**NOTICE OF ADDENDUM
ADDENDUM NO. 2**

**CONTRACT NO. 7939
MADISON MUNICIPAL BUILDING - RENOVATION**

This addendum is issued to modify, explain or correct the original Drawings, Specifications, or Contract Documents and is hereby made a part of the contract documents.

2 LEVEL 2 - W11 - HEAD, W17-SILL DETAIL
 A652 3' = 1'-0"

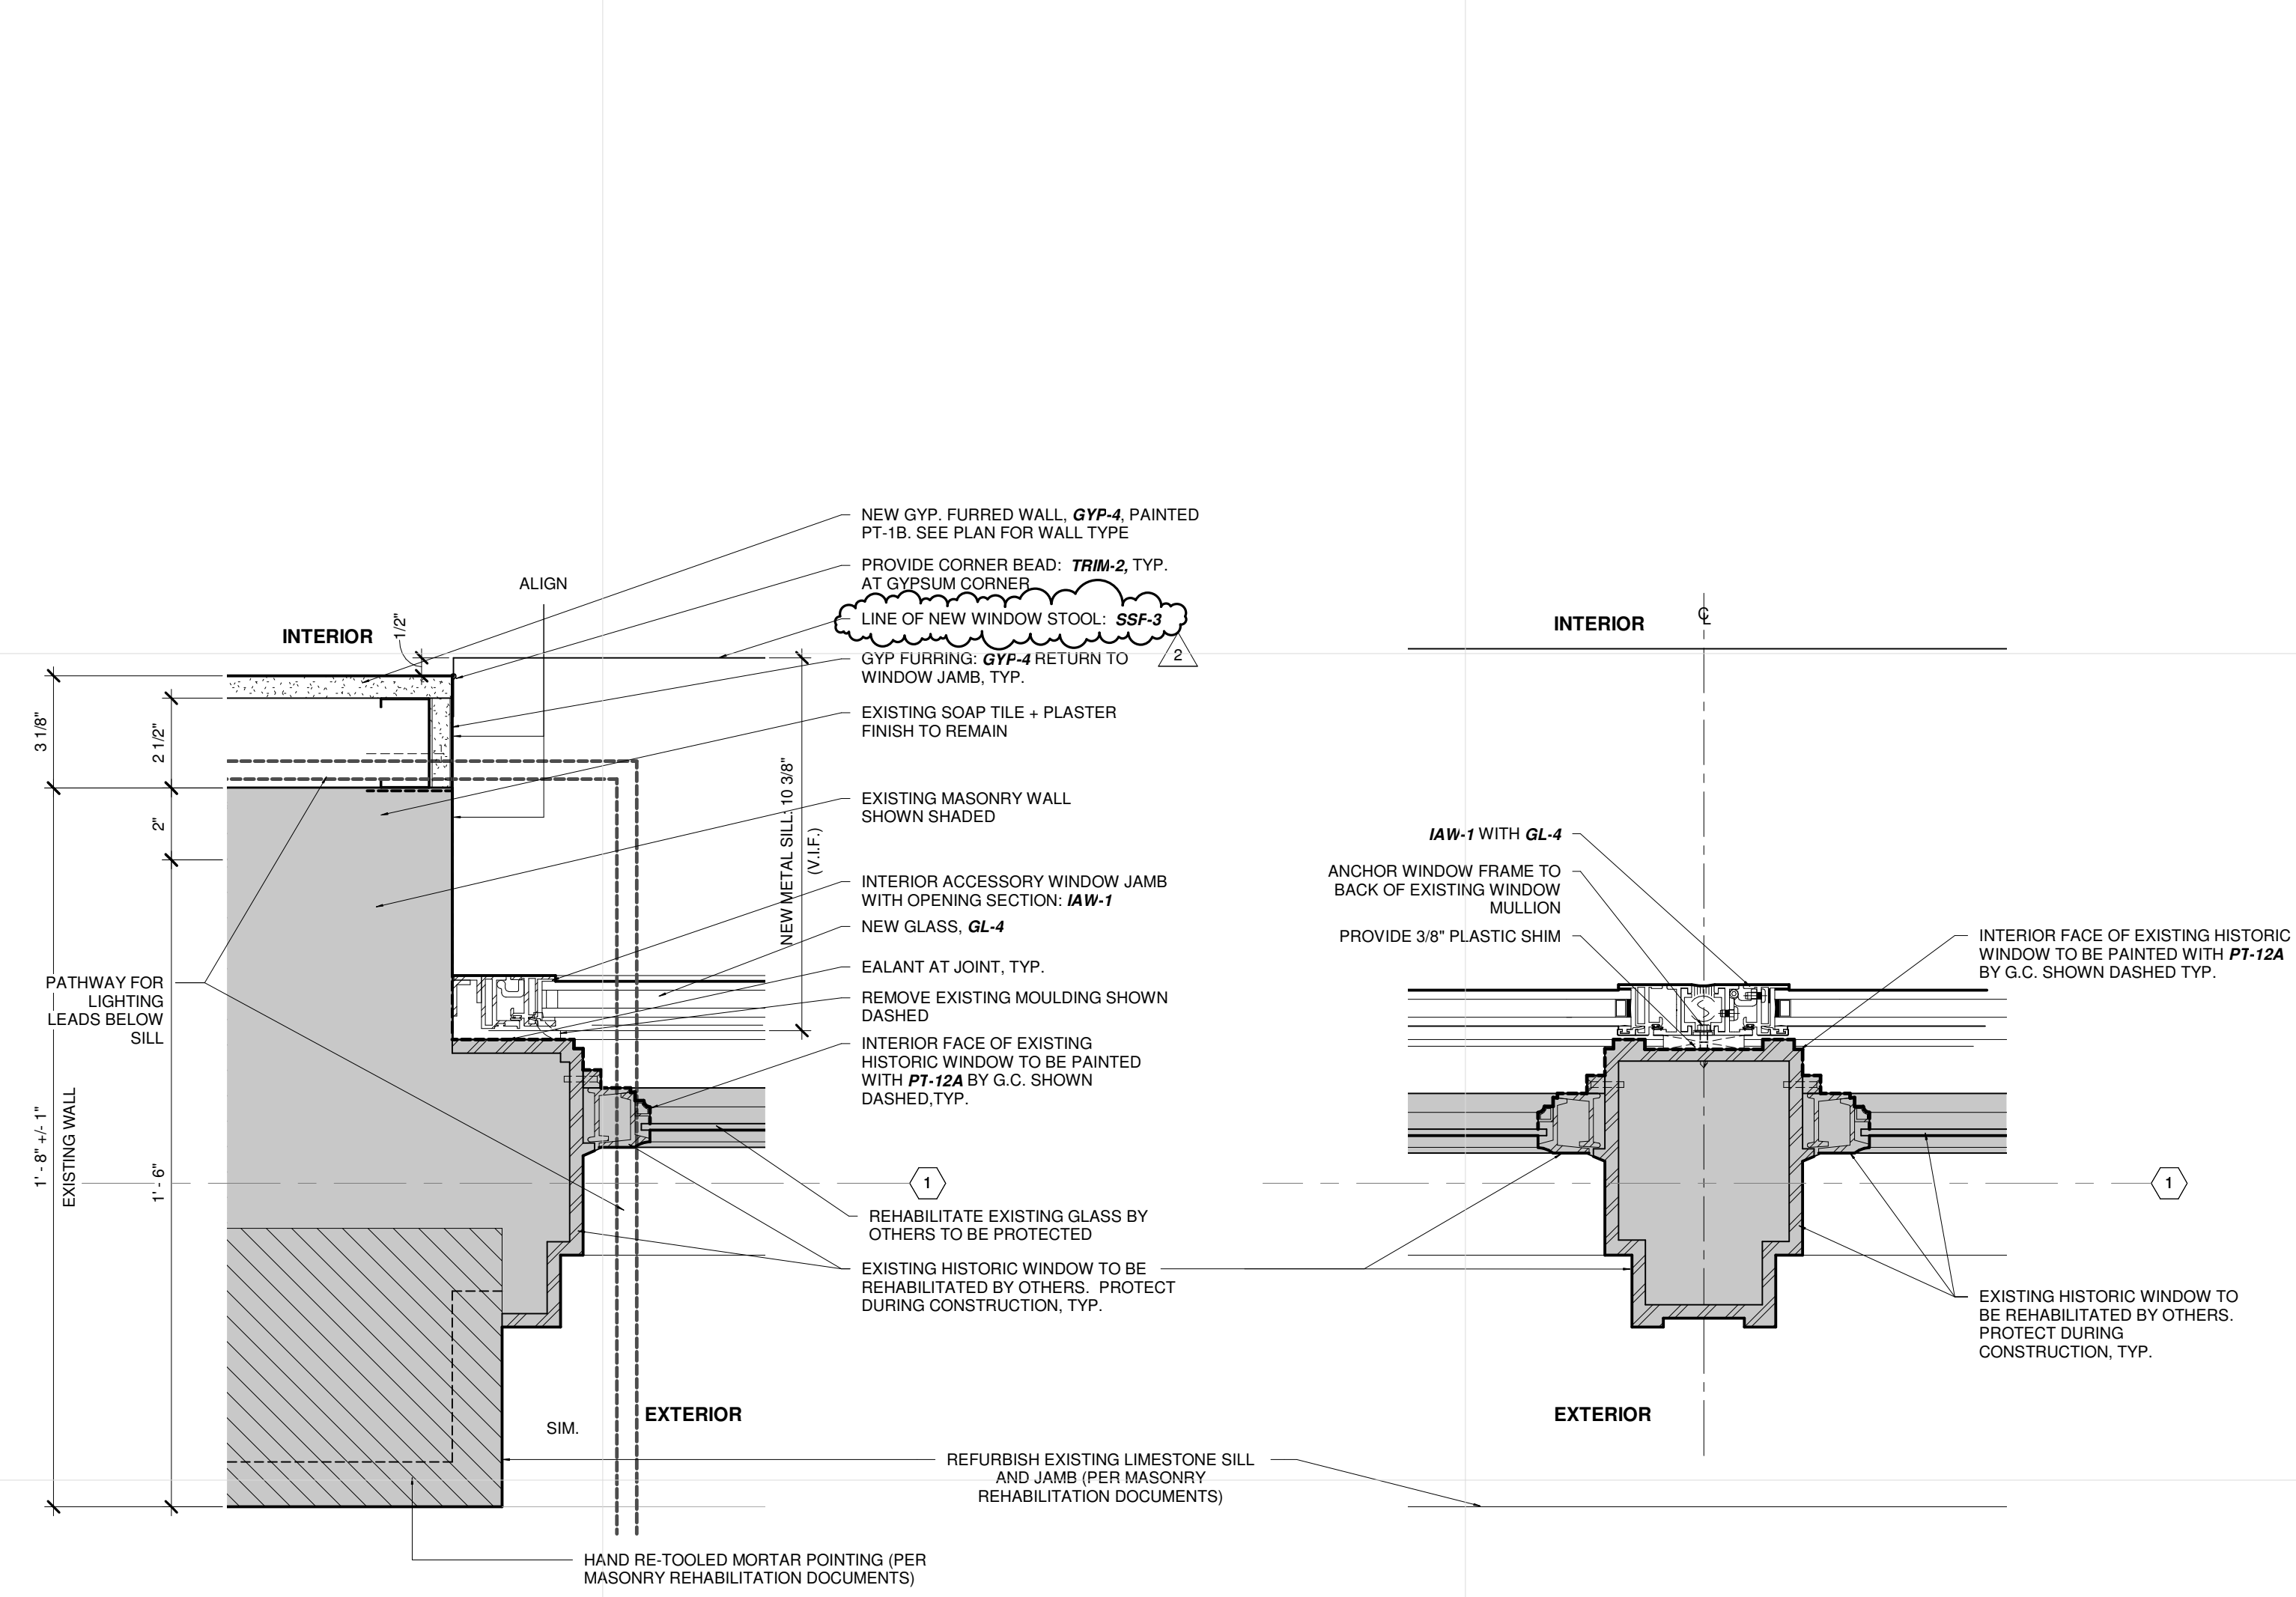
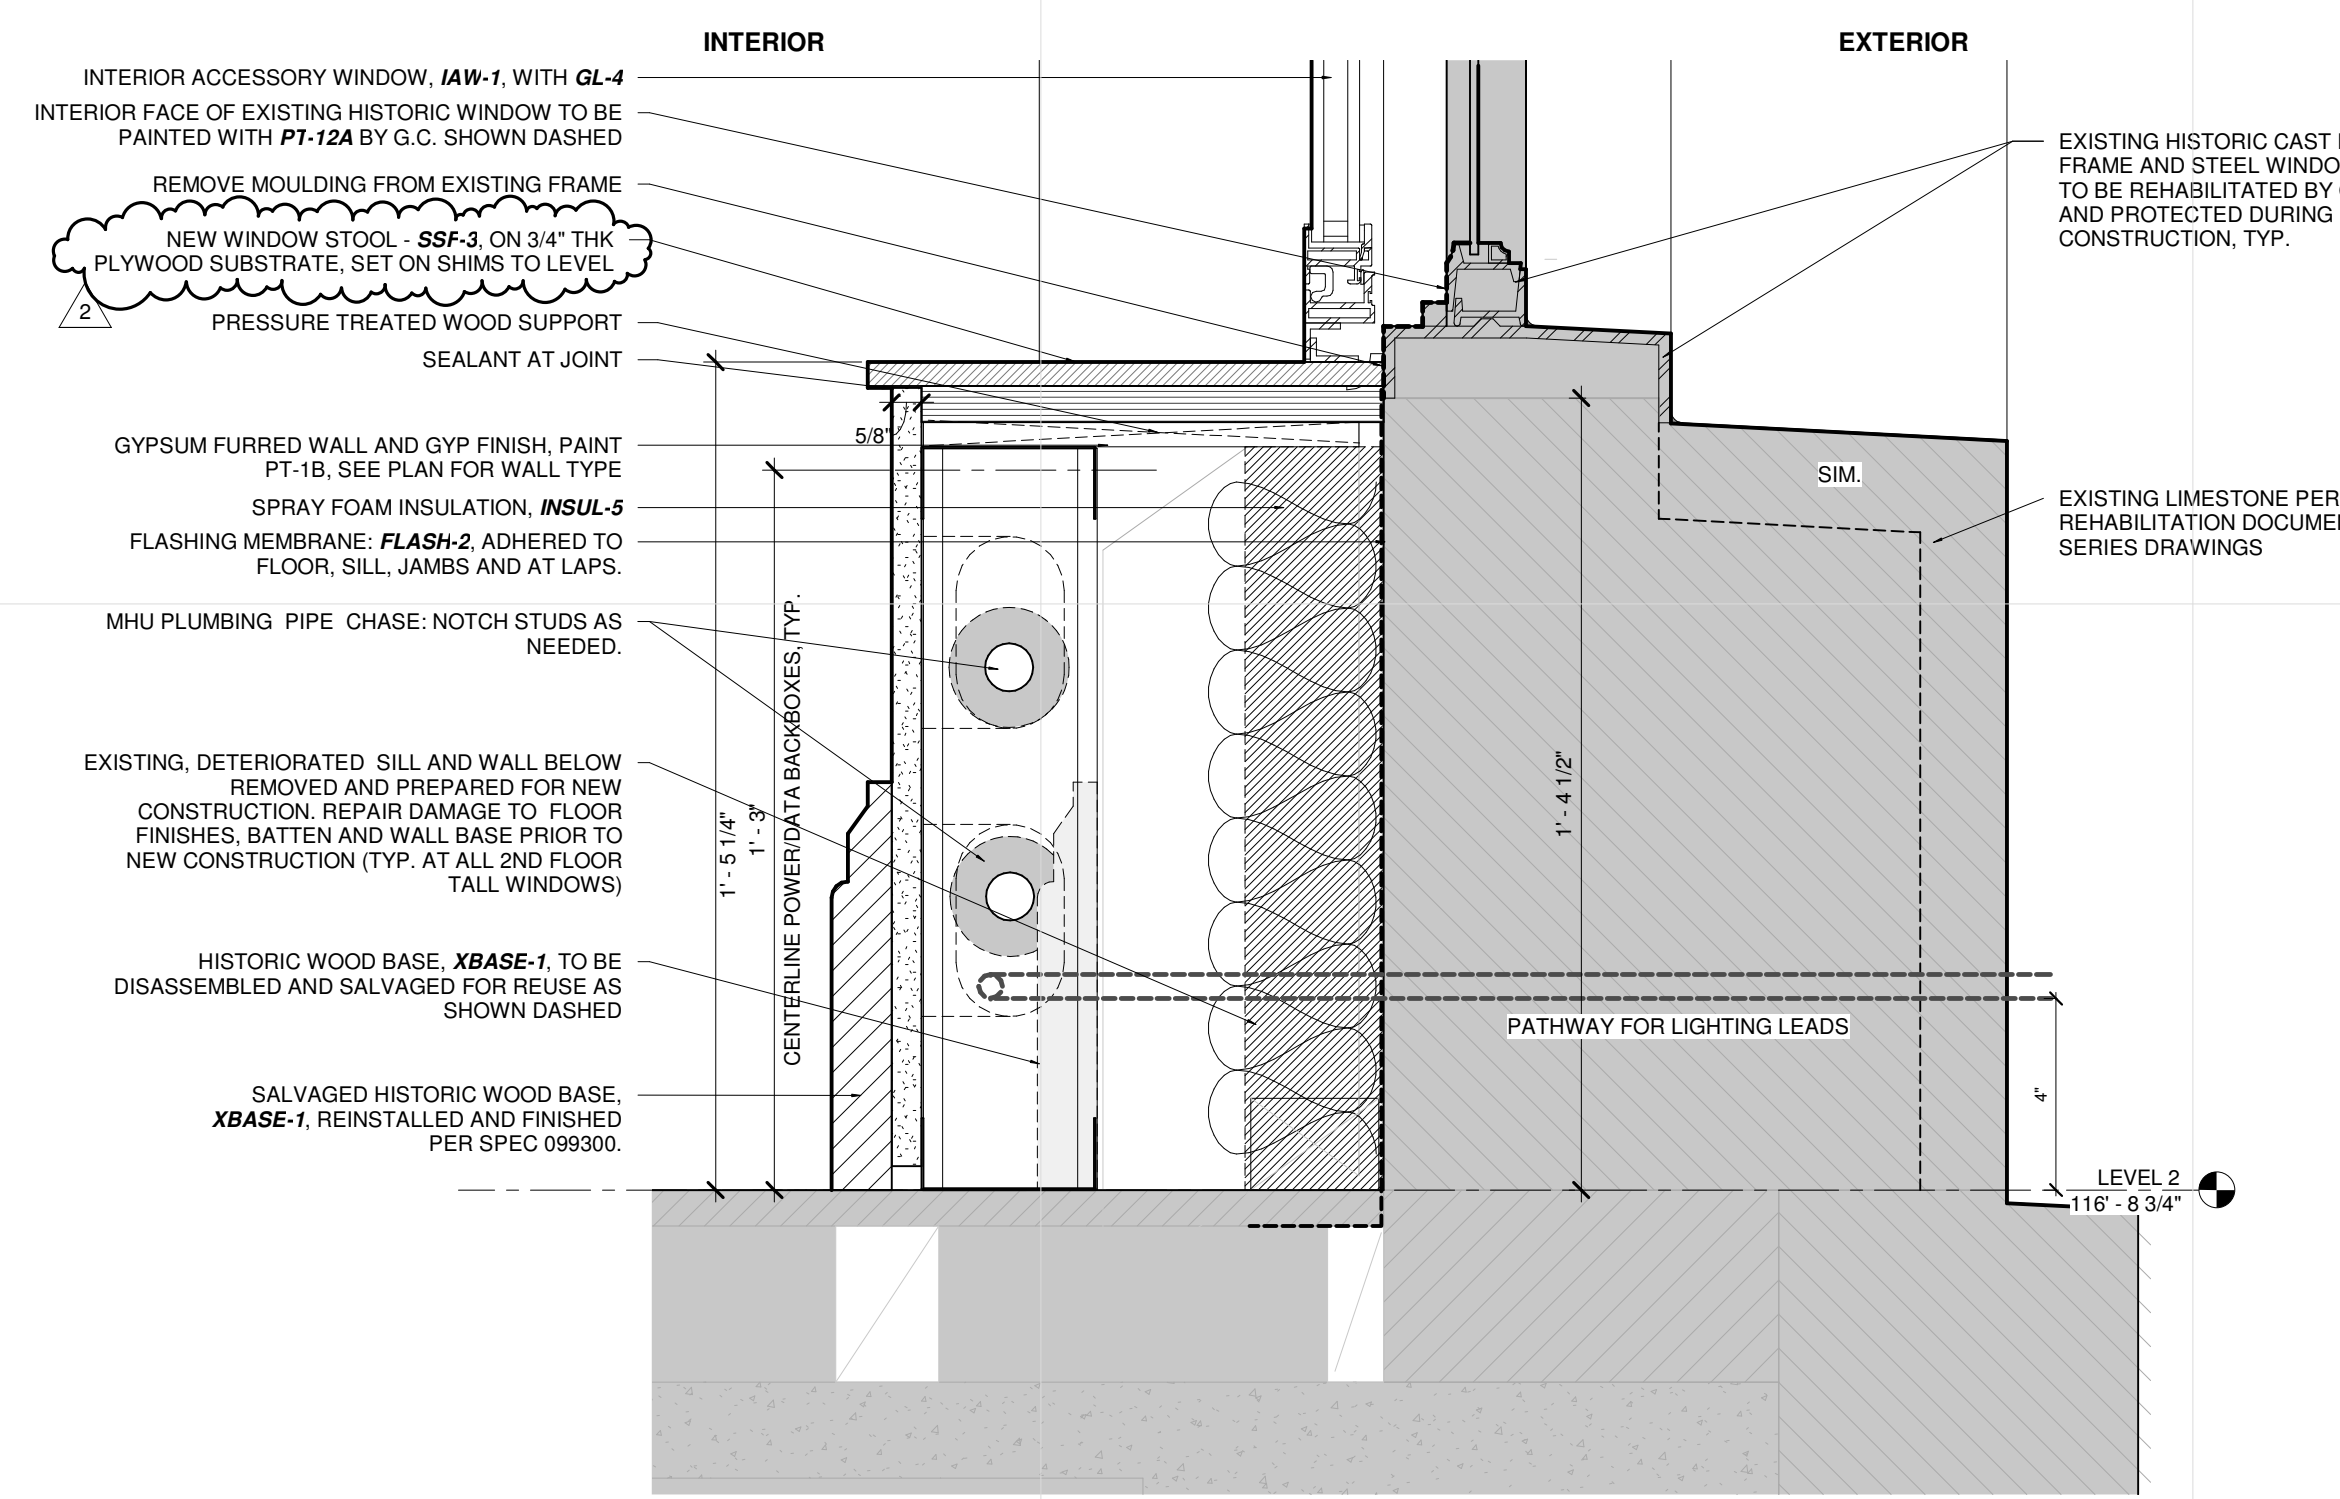
4. Details A620 through A624, and A651 through A654. Due to durability and cost concerns regarding the new metal window stools, these have been changed from MTL-3 to solid surface material SSF-3.
5. BE001. Amend general note 10 on sheet BE001 (drawing); Add language to general note 16 on sheet BE001 (drawing)
6. BE219. Revised stone numbers
7. BE338. See Clarifications Section below
8. BE356. See Clarifications Section Below
9. BE356.1. See Clarifications Section Below
10. BE356.2. See Clarifications Section Below
11. S101. See Structural Memo Attached.
12. S102. See Structural Memo Attached.
13. S103. See Structural Memo Attached.
14. S104. See Structural Memo Attached.
15. S190. See Structural Memo Attached.
16. S201. See Structural Memo Attached.
17. S302. See Structural Memo Attached.
18. S304. See Structural Memo Attached.
19. E300. See MEP Memo Attached.
